UNITED STATES PATENT AND TRADEMARK OFFICE

APPLICATION NO.	FILING DATE	FIRST NAMED INVENTOR	ATTORNEY DOCKET NO.	CONFIRMATION NO.
10/749,771	12/30/2003	James Shyu	07942.0031-00	1047
22852	7590	05/10/2005		
FINNEGAN, HENDERSON, FARABOW, GARRETT & DUNNER LLP 901 NEW YORK AVENUE, NW WASHINGTON, DC 20001-4413				
			EXAMINER PERT, EVAN T	
			ART UNIT 2826	PAPER NUMBER

Office Action Summary

DETAILED ACTION

The practice of claims 1-11 and 13-16 requires practice of the transition from Fig. 2D to 2E, without undue experimentation. Figs 2D and 2E are repeated here for clarity:

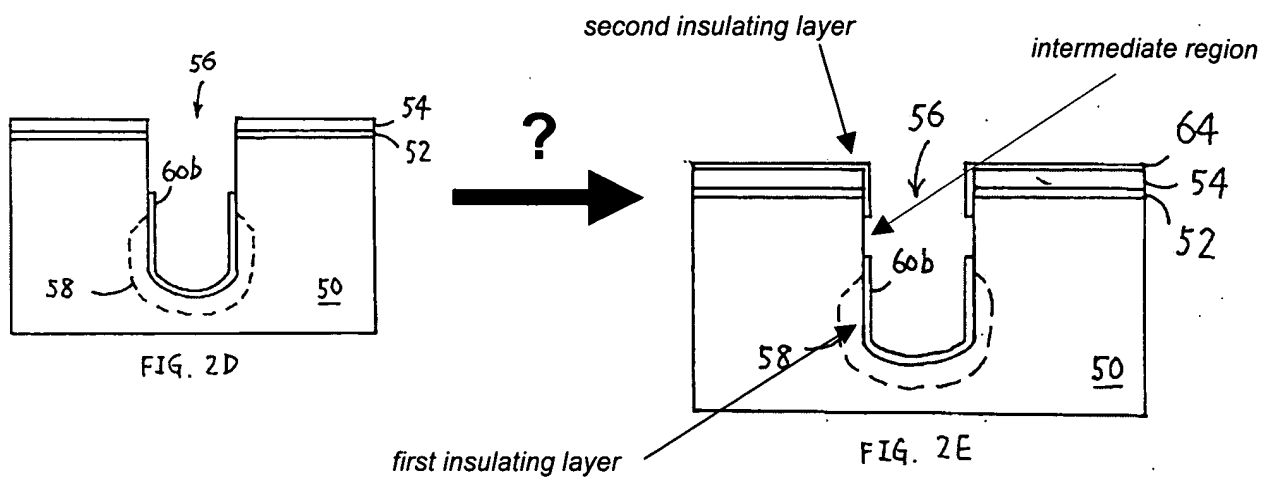
2. The specification is objected to for a lack of adequate explanation of how the transition from Fig. 2D to Fig. 2E is performed in accordance with the claimed invention, the transition from Fig. 2D to Fig. 2E being an essential part of enablement of the claim phrases: "the second insulating layer *being separated* from the first insulating layer *by an intermediate region*" (i.e. claims 1-11) and "forming a first insulating layer *up to a lower level* of the intermediate region...and forming a second insulating layer *down to an upper level* of the *intermediate region*" (i.e. claims 13-16).

The written description for enablement of the claim phrases identified above consists of a single “example” as being an “ALD” process to form layer 64 (at p. 7, [026]), such that the layer is controlled to extend only part way down the trench 56 sidewalls, as depicted in Fig. 2E.

That is, ALD is used to form layer 64 with a “separation” seen as a gap between the “first and second insulating layers” at the “intermediate region” (claims 5, 10 & 15).

Yet, applicant does not explain how an ALD process is used to form layer 64 as depicted in Fig. 2E (as is claimed) because ALD is known to be a “conformal” process:

That is, in the prior art, ALD would not readily be utilized to deposit a layer like 64 in Fig. 2E, without further instruction of how to use ALD *contrary* to its well-known benefits [i.e. applicant doesn't explain how applicant is using ALD for selective deposition on trench sidewalls rather than for conformal deposition over a contiguous surface inside the trench].

Particularly rejected claims 5, 10 and 15 are puzzling in view of evidence in the prior art that ALD is a *conformal process*. If layer 64 can not make its way to be evenly conformally deposited inside the trench as in Fig. 2E, then the first insulating layer would have problems with being conformally deposited by any method:

Perhaps applicant has omitted details of modifying an ALD process to perform a controlled selective sidewall deposition of layer 64 as seen in Fig 2E. Perhaps applicant has omitted disclosure of a sacrificial layer in forming layer 64. Perhaps applicant has omitted disclosure of masking in forming layer 64.

Correction and/or explanation are required.

Correction and/or explanation are required.

FIG. 6

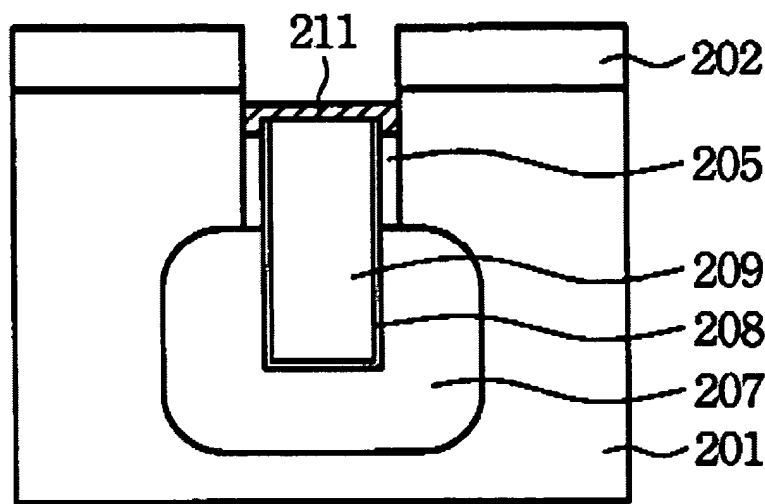
Regarding claim 17, Fig. 6 shows a structure that anticipates:

17. A trench capacitor comprising:
 a trench (200 in Fig. 2) formed into a semiconductor substrate including a lower region and an upper region (e.g. 211, 208 and 209 are in the trench into substrate 201, the trench inherently having upper top and lower bottom regions),
 a first conductive region formed around the lower region of the trench (plate 207),
 a collar oxide (205) formed on and into ("into" per Fig. 3) sidewalls of the trench at an intermediate region between the lower region and the upper region (i.e. anywhere between top and bottom of the trench being an "intermediate region"),
 a dielectric layer (208) formed along the sidewalls of the trench up to a level above the collar oxide (205); and
 a second conductive region (209) formed up to the level (i.e. "up to" and "above").

Regarding claim 18, a "third conductive region" (i.e. 211) is formed over the "second conductive region" (i.e. 209).

Regarding claim 20, the dielectric layer (i.e. 208 in Fig. 6) is formed "up to a top level of the collar oxide (205)," because 208 is "up to a top level of 205" and extending a little further to also be "above" as well, as is claimed in claim 17 from which claim 20 depends (see item 1 above).
